Access Compliance Report

Public Rights-of-Way

Intersection ID: 10016842	Main Street: N_TRYON_ST	Cross Street: N/A	Location: NW
ADA ID: AD6DEBF8C0BA	Ramp Type: PerpDiag	Initial Pass/Fail: Fail	Overall Compliance: No
			Severity Score: 21.25

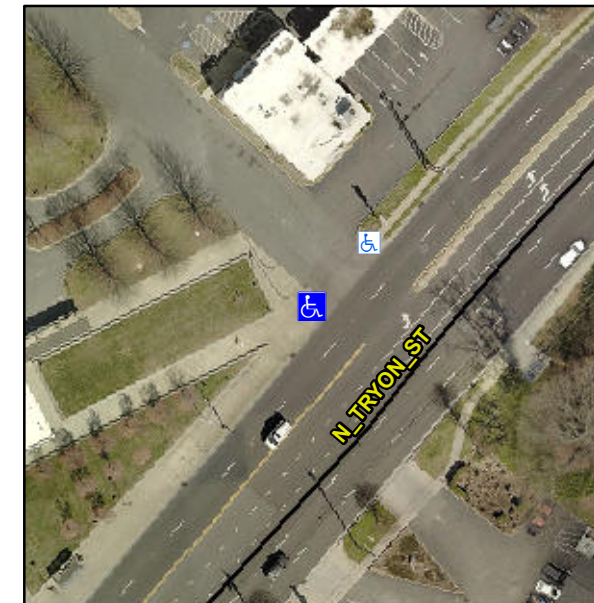
Not Found, R304.5.1, R304.5.3

Compliance	Description	Data	Compliance	Description	Data
N/A	Ramp Length (in)	113.0	Yes	Ramp Slope (%)	5.7
No	Ramp Width (in)	46.0	No	Ramp XSlope (%)	6.1
N/A	Flare Type LT	N/A	N/A	Flare Type RT	N/A
N/A	Flare Slope LT (%)	N/A	N/A	Flare Slope RT (%)	N/A
N/A	Flare Traversable LT?	N/A	N/A	Flare Traversable RT?	N/A
N/A	Landing Length (in)	N/A	N/A	DWS Provided?	N/A
N/A	Landing Width (in)	N/A	N/A	DWS Contrast?	N/A
N/A	Landing Slope (%)	N/A	N/A	DWS Length (in)	N/A
N/A	Landing X Slope (%)	N/A	N/A	DWS Full Width?	N/A
N/A	Landing Curb? (Y/N)	N/A	N/A	DWS Offset (in)	N/A
N/A	Shared Landing?	N/A			
N/A	Gutter Ponding?	N/A	N/A	Gutter Slope (%)	N/A
N/A	Gutter Lip Ht (in)	N/A	N/A	Gutter X Slope (%)	N/A
N/A	Painted X Walk1?	No	N/A	Painted X Walk2?	No
	X Walk 1 Direction	To SE		X Walk 2 Direction	To NE
N/A	X Walk 1 Width (in)	N/A	N/A	X Walk 2 Width (in)	N/A
	X Walk 1 Slope (%)	0.1		X Walk 2 Slope (%)	1.7
	X Walk 1 X Slope (%)	2.0		X Walk 2 X Slope (%)	2.8

Remove & Replace Curb Ramp With Two New Directional Ramps or Equivalent.
